**IN THE MATTER** of application CRC190445 by the Christchurch City Council for a comprehensive resource consent to discharge stormwater from within the Christchurch City area and Banks Peninsula settlements on or into land, water and into coastal environments

**SUMMARY OF SECTION 42A OFFICER REPORT OF MICHAEL CHARLES  
LAW**

**FOR CANTERBURY REGIONAL COUNCIL**

**14 November 2018**

**Figure 1 – Avon surface water network**

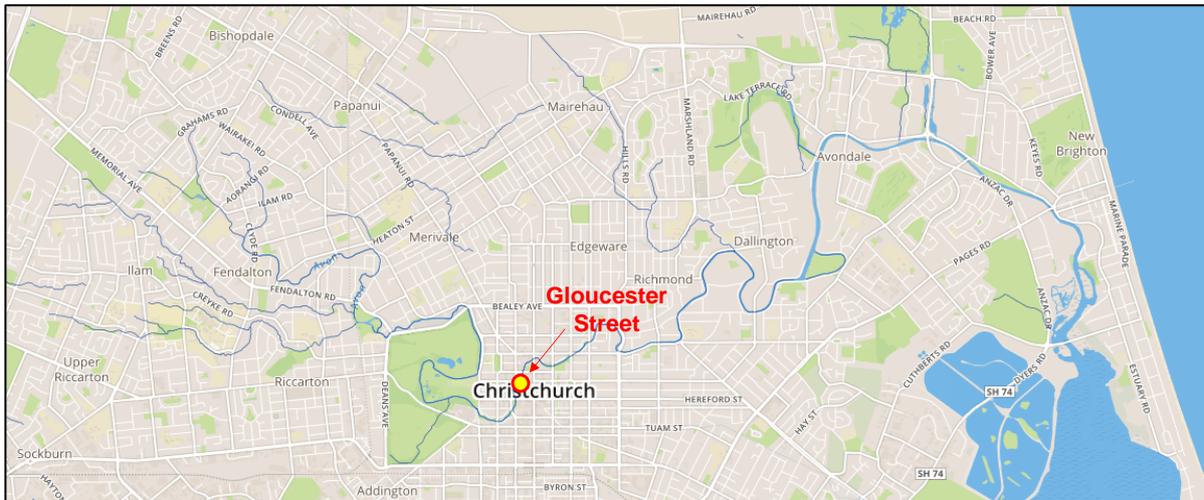
- 14 With performance only being measured at one location in each of the four modelled catchments, this will not reflect variations in effect across the catchment. Indeed, where the proposed target location is not at the outfall of the catchment, there is no mechanism by which Canterbury Regional Council (CRC) can control increases in downstream flood level, which could occur with unmitigated development downstream of the target location.
- 15 For example, the control location for the Avon catchment is Gloucester Street Bridge in the city centre. Approximately 75% of the Avon's stream network is downstream of this location (Figure 1) which means that the CSNDC will not control stormwater in the Avon catchment downstream of this point.
